Access Compliance Report

Public Rights-of-Way

Intersection ID: 8291	Main Street: TENNESSEE_AV	Cross Street: NELSON_AV	Location:	W
ADA ID: 0A66BC621D44	Ramp Type: BlendTrans1	Initial Pass/Fail: Fail	Overall Compliance: No	Severity Score: 12.5

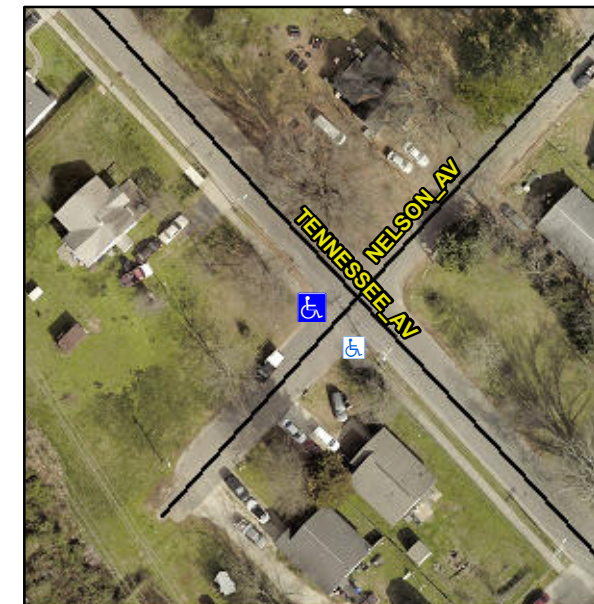
RAMP LIP 1.0, NO LT SW

Not Found, R304.5.3

Compliance	Description	Data	Compliance	Description	Data
N/A	Ramp Length (in)	47.5	Yes	BlendTrans Slope (%)	4.9
Yes	Ramp Width (in)	48.0	No	BlendTrans XSlope (%)	5.9
N/A	Flare Type LT	N/A	N/A	Flare Type RT	N/A
N/A	Flare Slope LT (%)	N/A	N/A	Flare Slope RT (%)	N/A
N/A	Flare Traversable LT?	N/A	N/A	Flare Traversable RT?	N/A
N/A	Landing Length (in)	N/A	N/A	DWS Provided?	N/A
N/A	Landing Width (in)	N/A	N/A	DWS Contrast?	N/A
N/A	Landing Slope (%)	N/A	N/A	DWS Length (in)	N/A
N/A	Landing X Slope (%)	N/A	N/A	DWS Full Width?	N/A
N/A	Landing Curb? (Y/N)	N/A	N/A	DWS Offset (in)	N/A
N/A	Shared Landing?	N/A			
N/A	Gutter Ponding?	N/A	N/A	Gutter Slope (%)	N/A
N/A	Gutter Lip Ht (in)	N/A	N/A	Gutter X Slope (%)	N/A
N/A	Painted X Walk1?	No	N/A	Painted X Walk2?	N/A
	X Walk 1 Direction	To SE		X Walk 2 Direction	N/A
	X Walk 1 Width (in)	N/A		X Walk 2 Width (in)	N/A
	X Walk 1 Slope (%)	2.1		X Walk 2 Slope (%)	N/A
	X Walk 1 X Slope (%)	4.1		X Walk 2 X Slope (%)	N/A

Remove & Replace Curb Ramp With Two New Directional Ramps or Equivalent.
